AGENDA – Planning Commission Meeting

CITY OF SARATOGA SPRINGS Thursday, March 26, 2020, 6:00 pm

PLANNING COMMISSION Staff Report

Riverview Plaza & Townhomes: Rezone and Concept Plan

Concept Plan

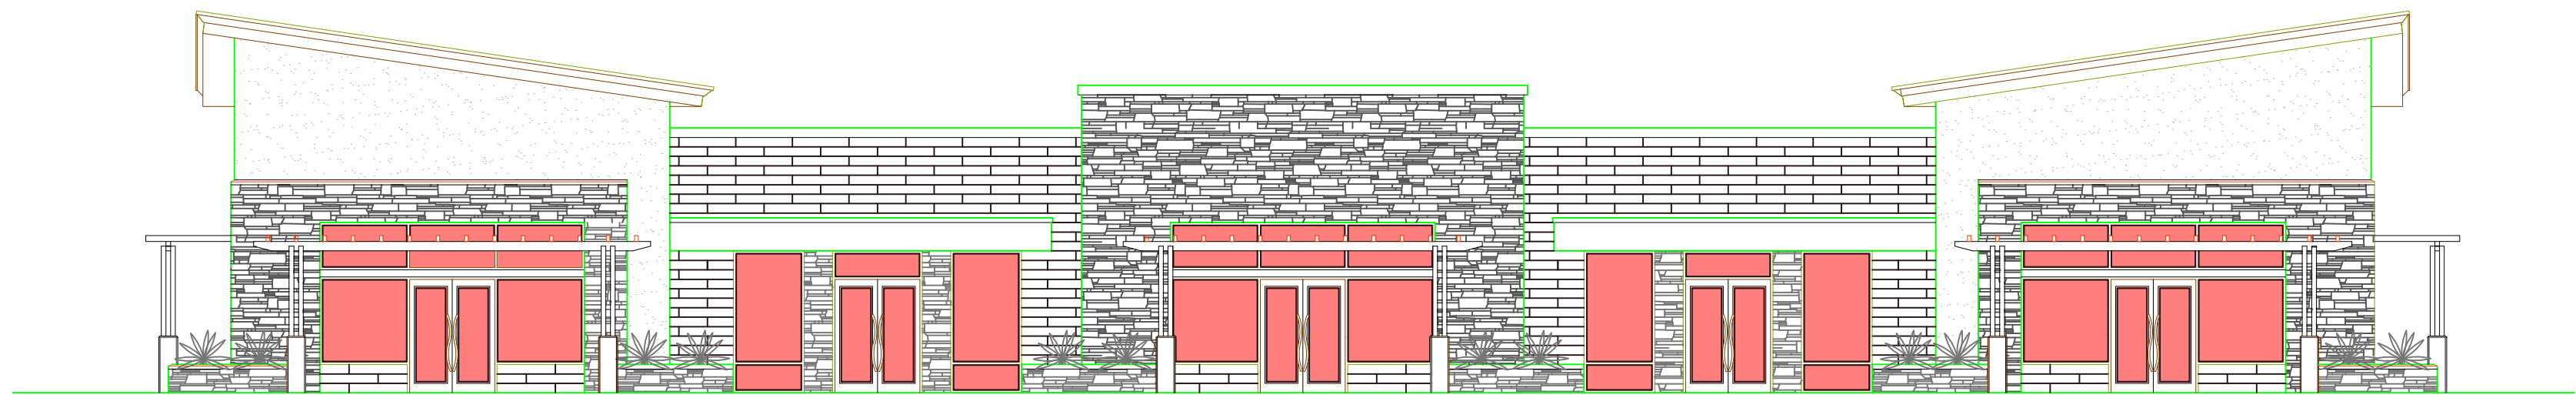
The proposed concept plan contains several outstanding redline corrections. Instead of resubmitting a concept plan multiple times, staff typically provides the applicant a first review and allows the applicant the choice of moving on in the development process or resubmitting until the applicant is comfortable with the level of corrections needed. In this case, two full reviews and one supplemental review have been made of the concept plan and rezone. The current concept plan is contained in Exhibit 4.

The Planning Review Checklist was used and identifies areas the concept plan is deficient regarding Code requirements. A few key items are listed below but the list is not exhaustive. Full compliant checklist will be used at the time of site plan approval provided the rezone is approved by the City Council.

- The curve of Riverside must be modified to meet Engineering requirements.

- UDOT may require a right-in/right-out access in anticipation of potential future median.
- A few remaining contradictory or outdated pieces of information must be harmonized (e.g. County acreage vs. surveyed, company ownership records, etc.)
- Overall density appears to comply with the standards of the Mixed-Use Zone.
- Riverbank stabilization, open space improvements, and other site plan specific items will be reviewed for completeness and code compliance through the site plan and subdivision processes.

1. All requirements of the City Engineer shall be met, including but not limited to those in the attached report.
2. All requirements of UDOT concerning access shall be met.
3. Additional items will require further review at the subdivision/site plan review level.
4. The plans shall comply with all Code requirements.
5. Any comments providing direction from the Planning Commission: _____
